Detailed Site Plan

DSP-20003-02

Popeyes at Mill Branch Crossing

STAFF REPORT

Figure 1: Boundary Plat of the Subject Property

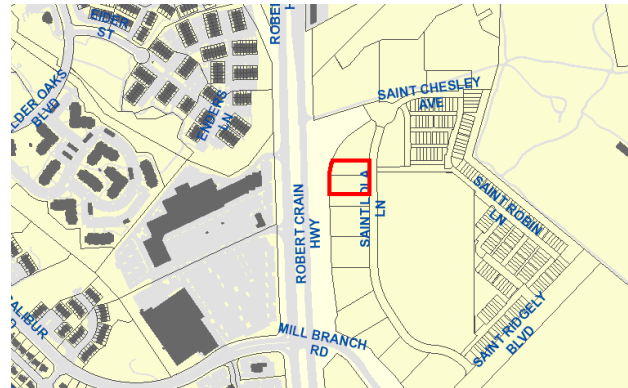
Notes: *Under the original DSP-20003, only infrastructure was approved and no final design for development of the commercial area was approved. Given final configuration of the commercial parcels was unknown at that time, since specific tenants and buildings were not part of that approval, the commercial area was platted as outlots to facilitate grading while indicating future DSP approval for the commercial development and final parcel configuration would still be needed. The property is currently comprised of part of existing Outlots 9 and 10, recorded in Plat Book ME 262 page 52 of the Prince George's County Land Records. However, Sheet DSP-1 reflects three (3) existing outlots (Outlots 8, 9, and 10) and proposes three (3) new parcels (Parcels 8, 9, and 10). Reference to Outlot 8 should be removed, and since at the time of the subject DSP, the adjacent outlots have yet to receive plat approval for final parcel configuration, the DSP should be revised to reflect the existing outlot designations. Conditions are included herein requiring the applicant to revise the coversheet and subsequent plan sheets to reflect the specific

subject property of this DSP (existing Outlots 9 and 10), proposed Parcel 9, and all other adjacent lots for future development as outlots with their current platted correlating number.

****Site Data Note 11 on Sheet DSP-1 reflects three existing outlots (Outlots 8, 9, and 10) and proposes three new parcels (Parcels 8, 9, and 10). The site plan, however, only proposes Parcel 9. A condition is included herein requiring the applicant to revise Site Data Note 11 to reflect Parcel 9 as the only proposed parcel area for this DSP.**

1. Prior to certificate approval of this detailed site plan (DSP), the applicant shall:
 - a. Revise the cover sheet and plans to identify the subject property of this DSP as proposed Parcel 9, with the abutting lots retaining an outlot designation for future development.

- b. Revise the Site Data Note 11 to reflect Parcel 9 as the only Proposed Parcel Area and remove reference to existing Outlot 8.
 - c. Revise the Minimum Building Setback on Sheet DSP-4 to accurately reflect the correct orientation and the required setback dimensions.

Figure 2: Detailed Site Plan

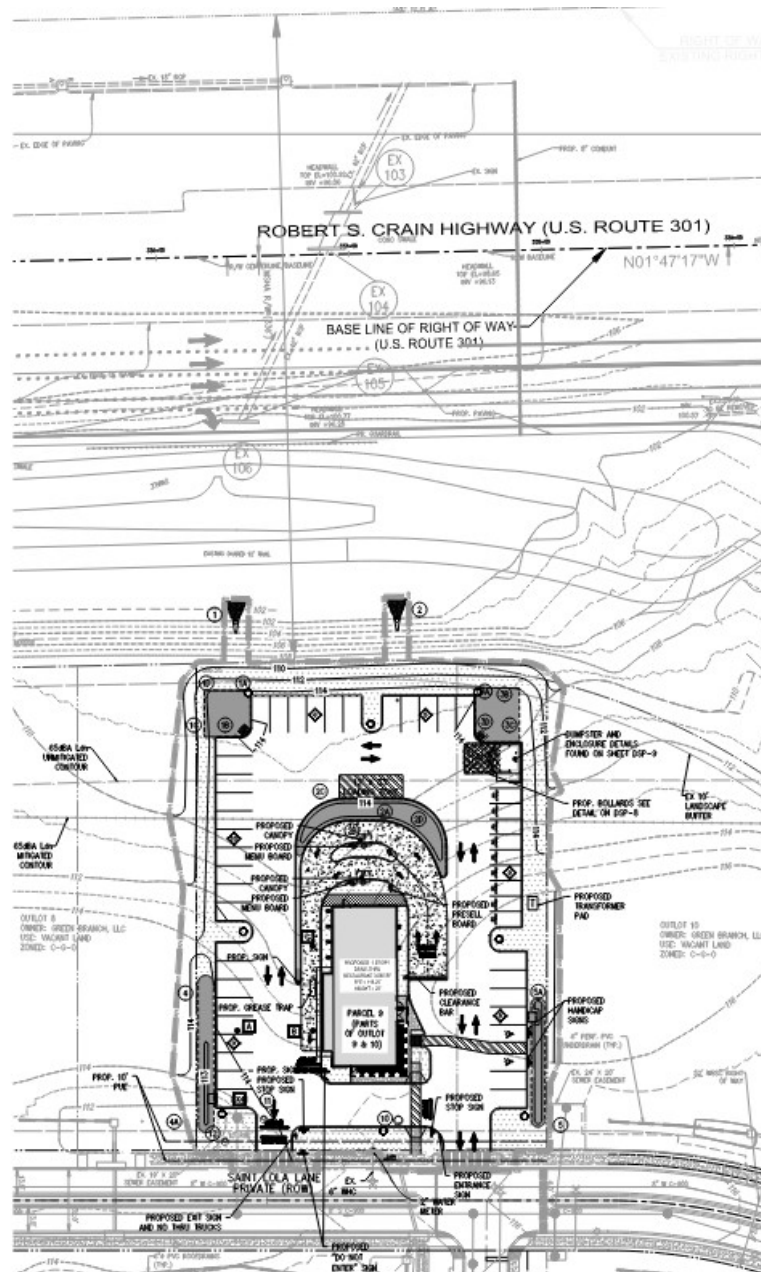
The subject development is oriented towards Saint Lola Lane and has vehicular and pedestrian access from Saint Lola Lane. The building is one-story and is 25 feet in height. Two drive-through lanes start from the north of the building, with two separate menu display boards, and then merge into one lane before the pick-up window located on the south side of the building.

Figure 3: Proposed East (upper) and South (lower) Elevations

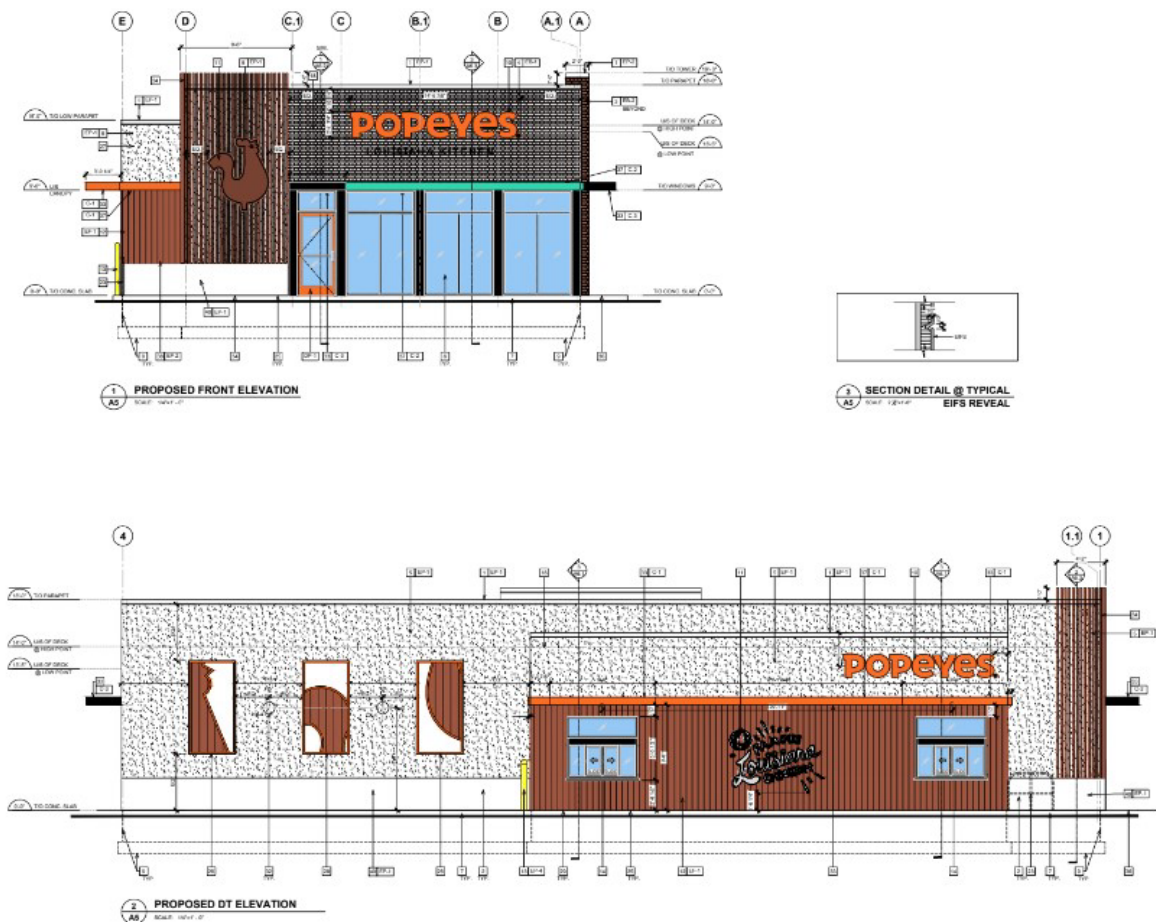
The architectural design of the proposed building is contemporary with a flat roof. The building is finished with a mix of materials, including brick veneer, exterior insulation and finish systems, glass, aluminum tubes, and pre-finished metal cap. The materials are arranged in a geometric pattern.
